November 5, 2004

Allison Galloway  
Chair, Santa Cruz Division Academic Senate

Re: First Draft 2005-2020 Long Range Development Plan

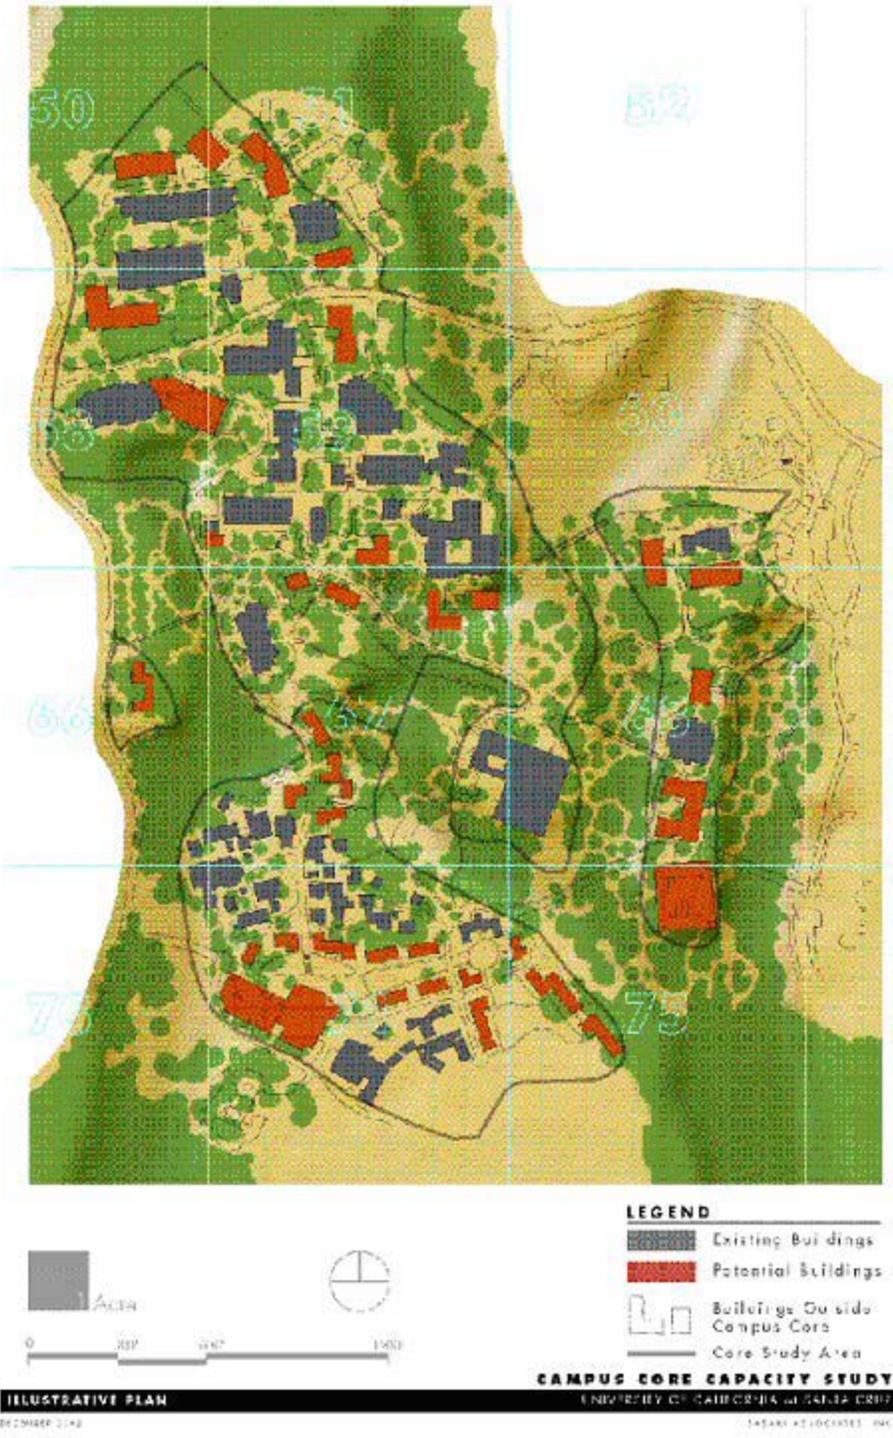
The Committee notes that this amount of infill development is inconsistent with the conclusions of a recent (2003) published campus report “UC Santa Cruz Campus Core Capacity Study”. The Capacity Study that was prepared by paid consultants indicates quite clearly that the campus core can be used only for an additional 836,000 ogsf. The Campus Core Capacity Study finds space for only 40 % of the development proposed in the LRDP!

Although there are certain to be differences in the assumptions of the two capacity studies, the large discrepancy must be resolved prior to issuing the draft LRDP for environmental review. There are also obvious infrastructure costs and phasing implementation aspects concerning the amount of development that can occur in the campus core.

For reference the next two pages present the Executive Summary and the development map from the Campus Core Capacity Study.
